UNITED STATES
DEPARTMENT OF THE INTERIOR
BUREAU OF LAND MANAGEMENT

FORM APPROVED
OMB NO 1004-0135
Expires: July 31, 2010**SUNDRY NOTICES AND REPORTS ON WELLS**
Do not use this form for proposals to drill or to re-enter an abandoned well. Use form 3160-3 (APD) for such proposals.

8. Well Name and No
CC TANK UNIT FEDERAL 49. API Well No
30-015-2020310. Field and Pool, or Exploratory
DAGGER DRAW; UPPER PENN,S11. County or Parish, and State
EDDY COUNTY, NM**SUBMIT IN TRIPLICATE - Other instructions on reverse side.**1. Type of Well **PGW**
☒ Oil Well ☐ Gas Well ☐ Other2. Name of Operator **YATES PETROLEUM CORPORATION** Contact **TINA HUERTA**
Mail: **tinah@yatespetroleum.com**3a. Address
**105 SOUTH FOURTH STREET
ARTESIA, NM 88210**3b. Phone No. (include area code)
Ph: **575-748-4168**
Fx: **575-748-4585**4. Location of Well (Footage, Sec., T., R., M., or Survey Description)
Sec 8 T20S R24E NWSE 1830FSL 1980FEL**12. CHECK APPROPRIATE BOX(ES) TO INDICATE NATURE OF NOTICE, REPORT, OR OTHER DATA**

Conditions of Approval

WELL NAME: CC Tank Unit Fed. #4 FIELD: Dagger Draw West

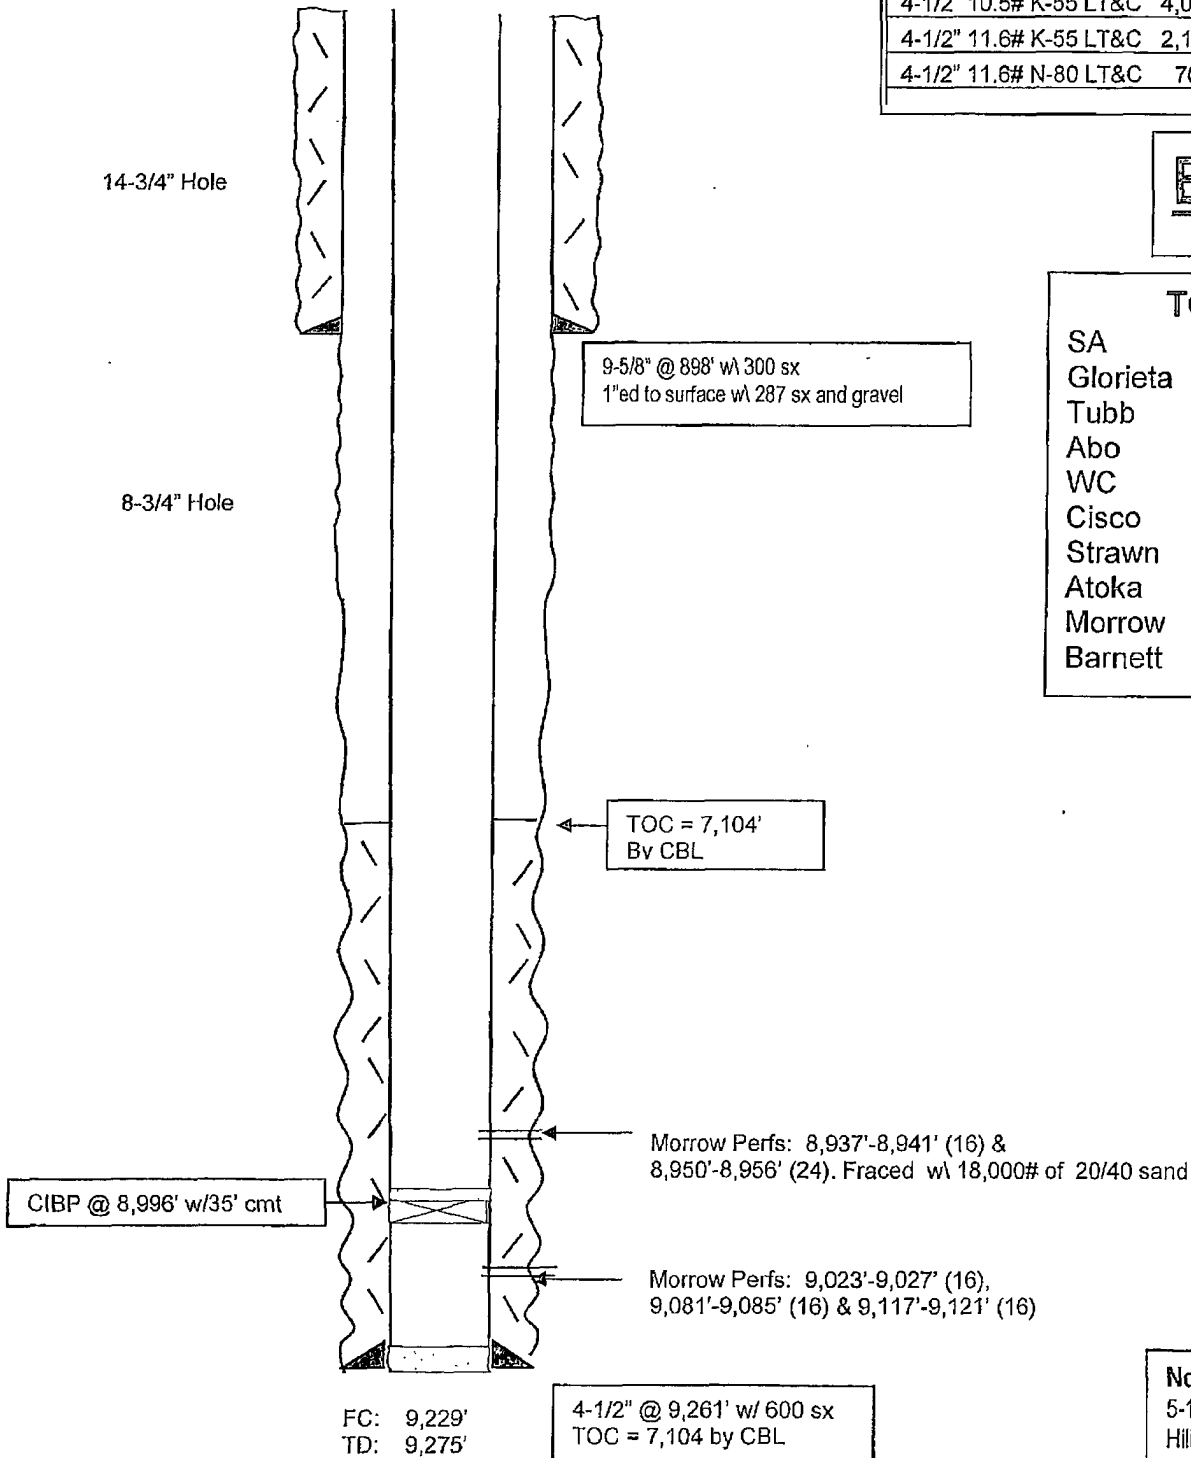
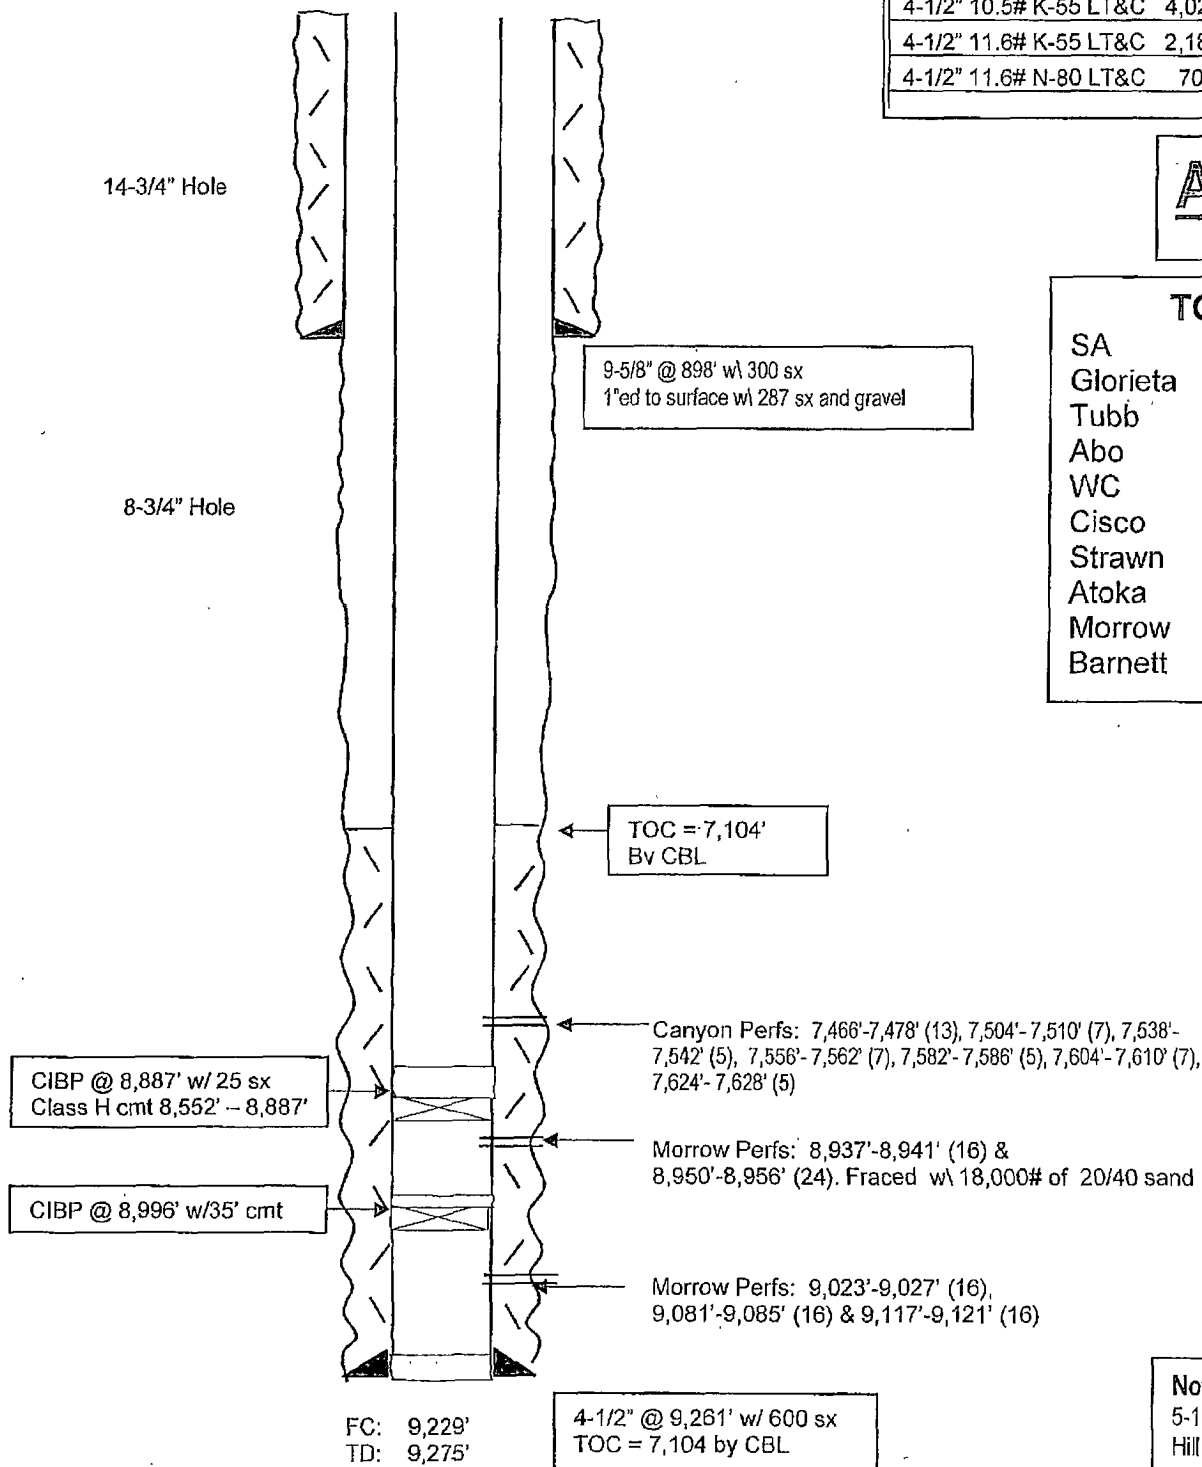
3. **Provide BLM with an electronic copy (Adobe Acrobat Document) of the cement bond log record of Step 2 (NOI procedure). Less than 500' between the proposed top perforation and top of cement or lack of a 500' overlap above next casing shoe may require remediation. The BLM CFO on call engineer may be reached at 575-706-2779.**

9. **Step 2 – cement plug shall be set across the Morrow perforations. Tag the cement on the existing CIBP at 8,996'. Pump a minimum of 25 sacks of neat Class H. Plug shall be tagged at 8,850' or shallower. Operator may pump sufficient cement to obtain the desired top above the proposed CIBP at 8,887', which is deleted with this procedure. This plug will cover the upper Morrow perforations and the top of the Morrow formation.**
